MONTGOMERY COUNTY HISTORIC PRESERVATION COMMISSION
STAFF REPORT

Address:	5615 Midwood Road, Bethesda	Meeting Date:	6/26/2024
Resource:	Contributing Resource (Greenwich Forest Historic District)	Report Date:	6/18/2024
Applicant:	Dave and Nancy Nathan (James O'Brien, agent)	Public Notice:	6/12/2024
Review:	Historic Area Work Permit	Tax Credit:	No
Permit No.:	1067474	Staff:	Chris Berger
Proposal:	Fenestration alterations.

DEMO PLAN
WORK TO BE PERFORMED
IN CLOUDED AREA ONLY

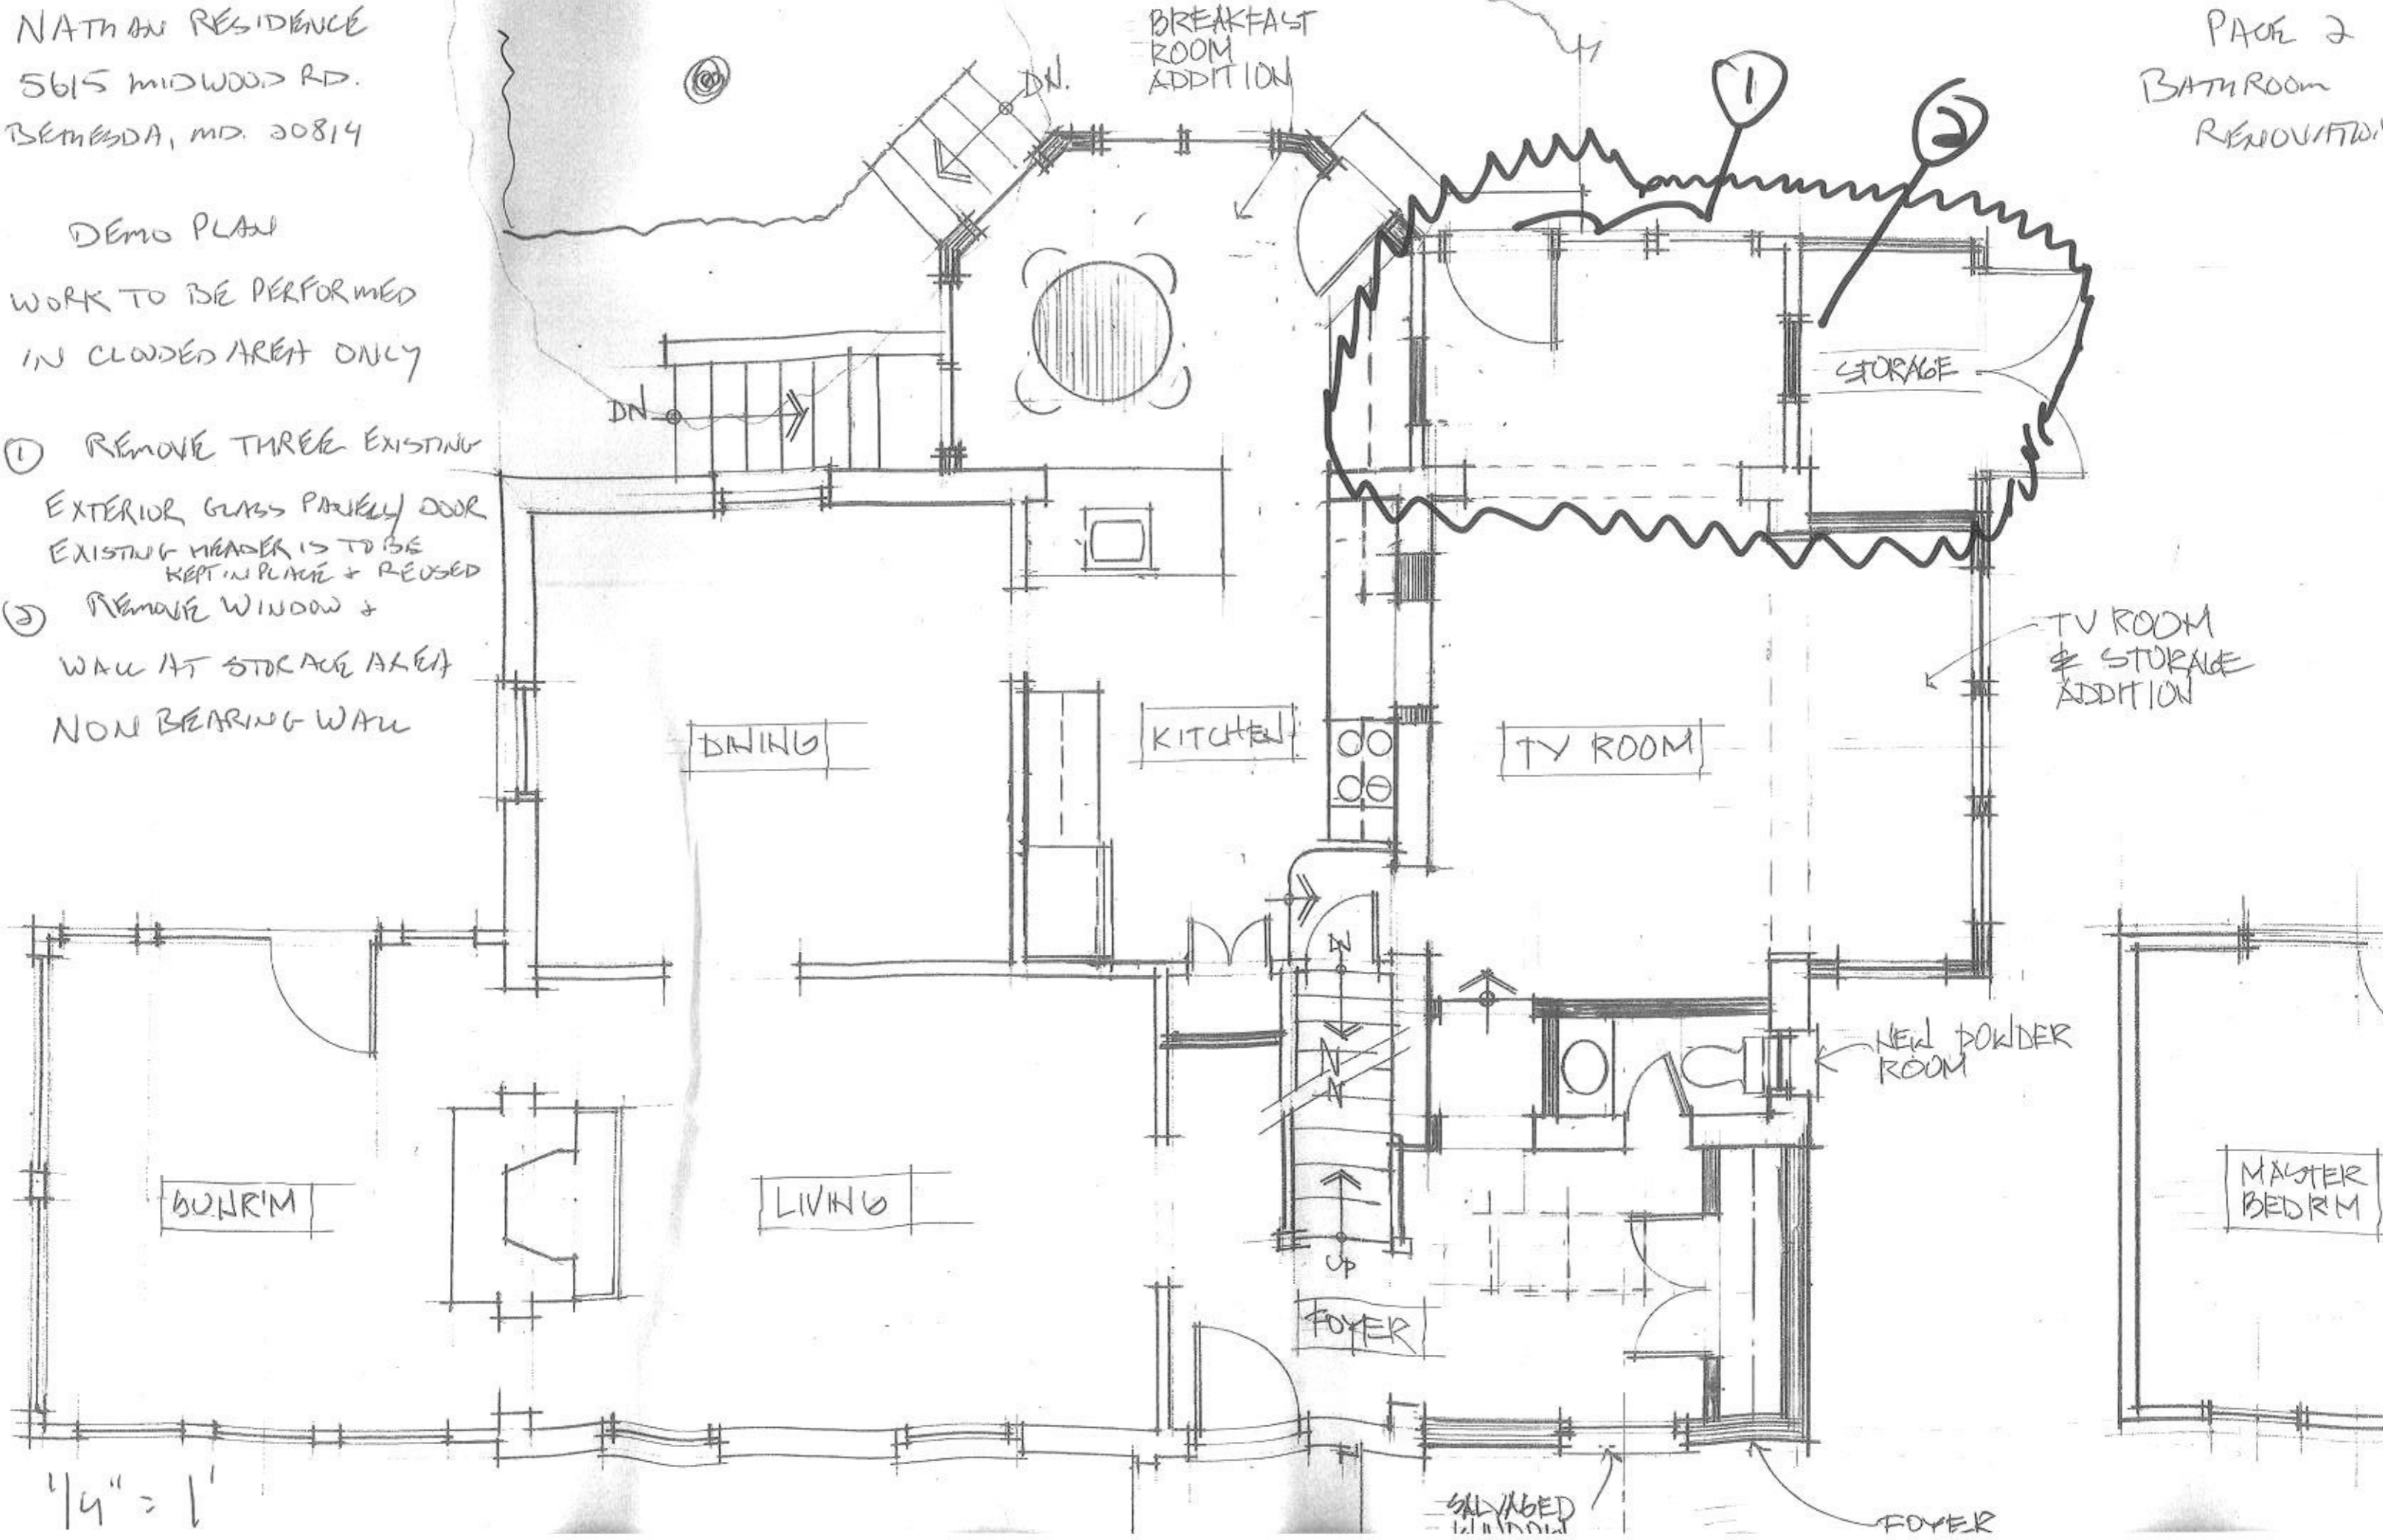
The smaller door opening will require infill on the wall, but the applicant has not indicated the material. The casing material and size also have not been indicated. Staff seeks a condition that information is added to the plans. Staff also seeks a condition that if any hardscaping is altered, the applicant must provide plans to show the proposed changes as a separate HAWP or as a revision to this HAWP application.

1. Applicant must include the proposed infill material and casing material and dimensions on the architectural drawings.
2. If any hardscaping will be altered, the applicant must provide plans to show the proposed changes as a revision to this HAWP or as a separate HAWP application.
